DEVELOPMENT REVIEW COMMITTEE (DRC) COMMENT REPORT

PROJECT NAME: Las Olas East Parking

CASE NUMBER: PLN-REZ-20010001 with PLN-SITE-20010001

REQUEST: Rezoning Request with Associated Site Plan Level II
Review: Automotive Parking Facility

DEVELOPMENT SITE COMMENTS

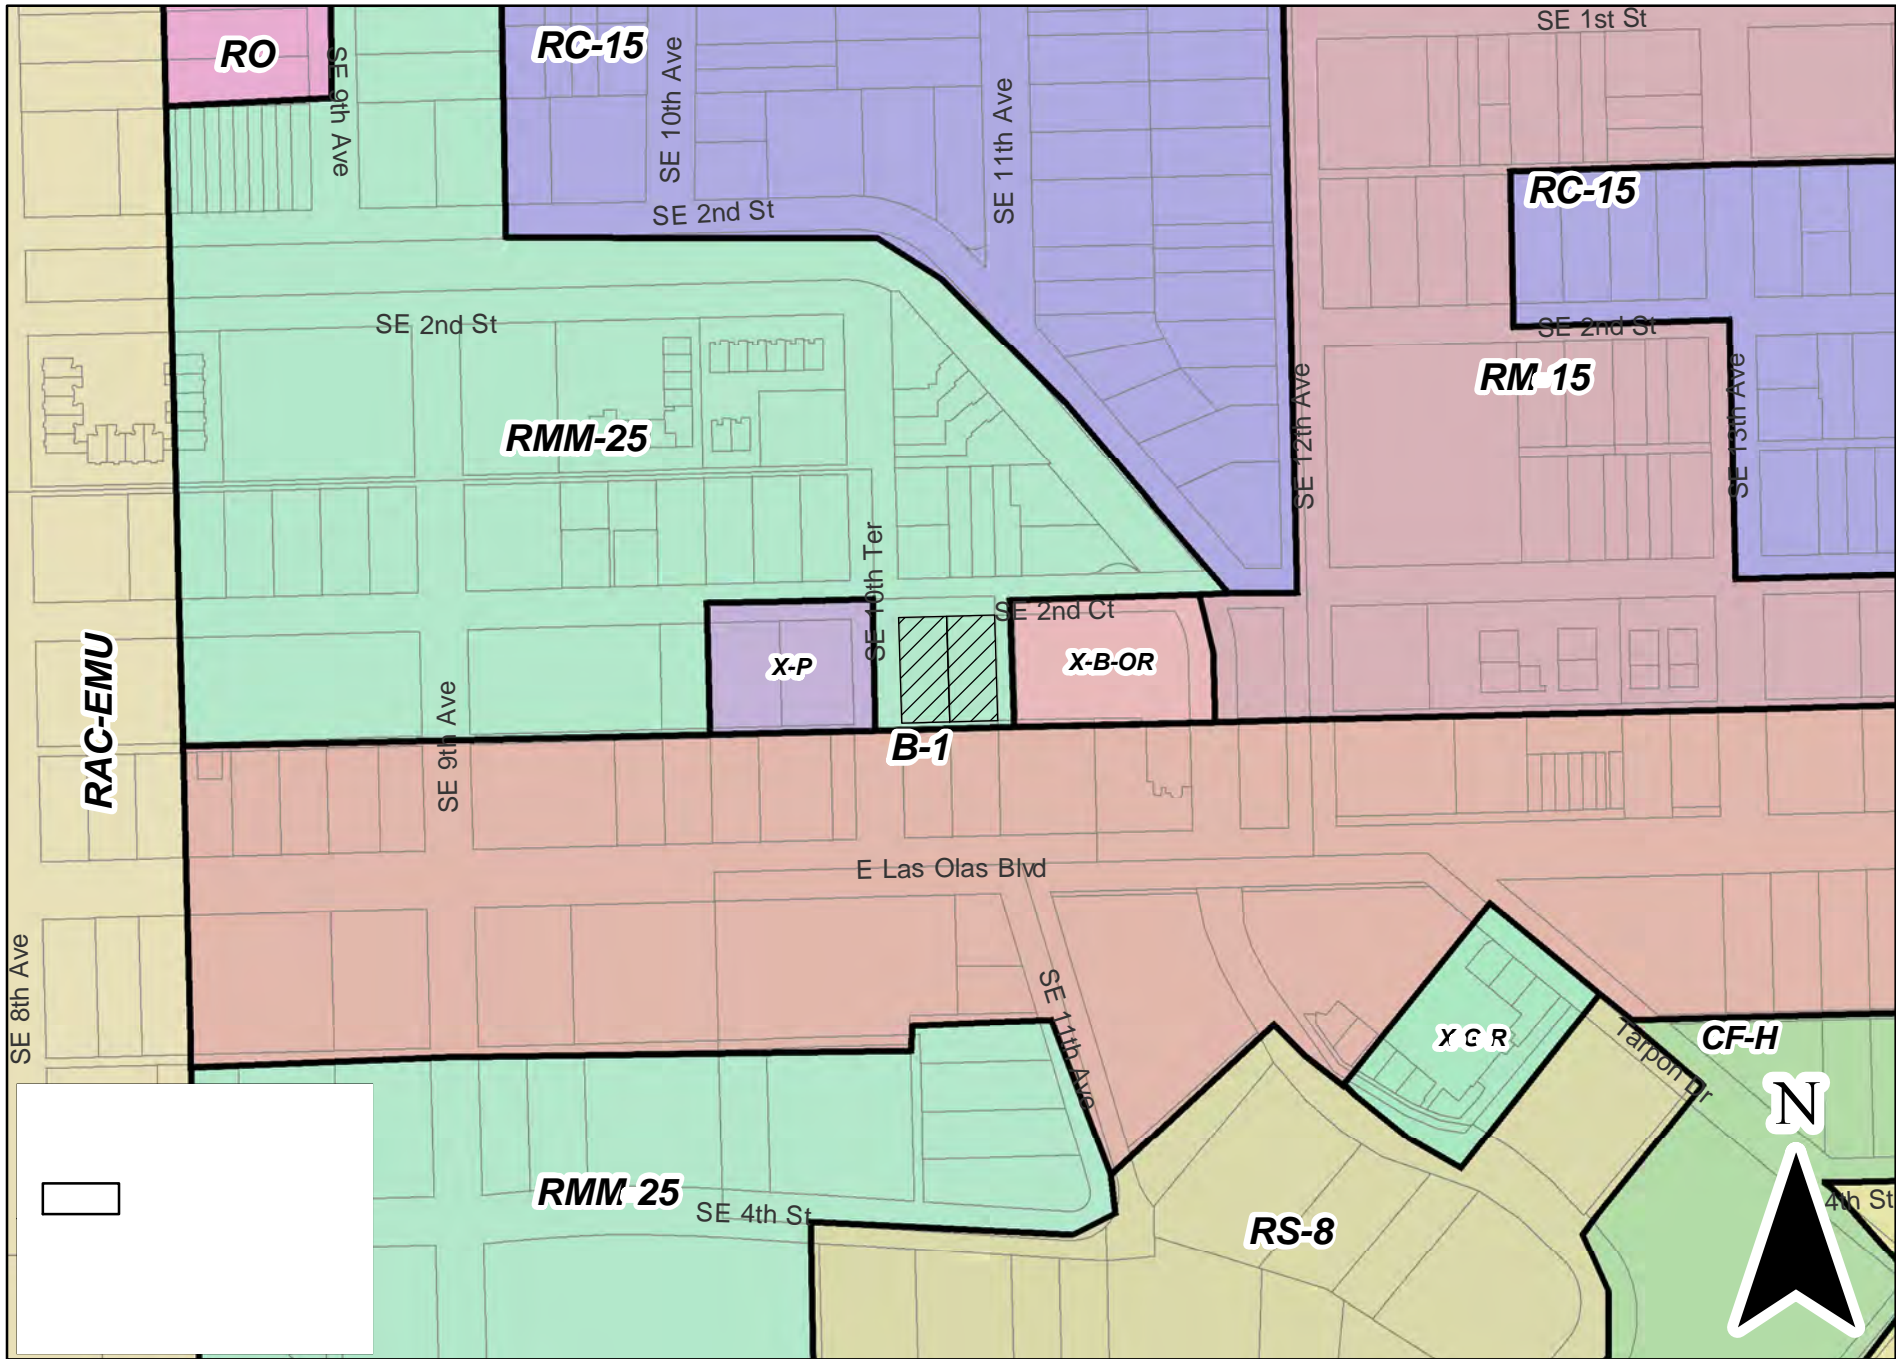
6. Provide documentation such as a Unity of Title or a Site Plan that demonstrates that the parcel immediately east of the proposed site, Lot 6, Block 21, is part of the development site for 111 East Las Olas Boulevard to determine that the lot is not considered a residential property. If Lot 6, Block 21 parcel is not part of the 111 East Las Olas Boulevard property, the parcel is considered a residential property. Based on the definition for residential property per ULDR, Section 47-35, Definitions the proposed site will be required to adhere to the buffer yard requirements of ULDR, Section 47-25.3, Neighborhood Compatibility Requirements if Lot 6, Block 21 is considered a residential property.

7. Plan sheet GP-1 depicts a portion of the dumpster door that swings into the drive aisle of the ten-foot (10') alley. Reconfigure the dumpster to ensure that the door does not swing into the alley drive aisle.

8. The proposed parking angle in the southeast corner of the parking lot is thirty-two (32) degrees however pursuant to Section 47-20.11, Geometric Standards, Parking Requirements, the parking angle is required to be 30 degrees. Revise the plan accordingly.
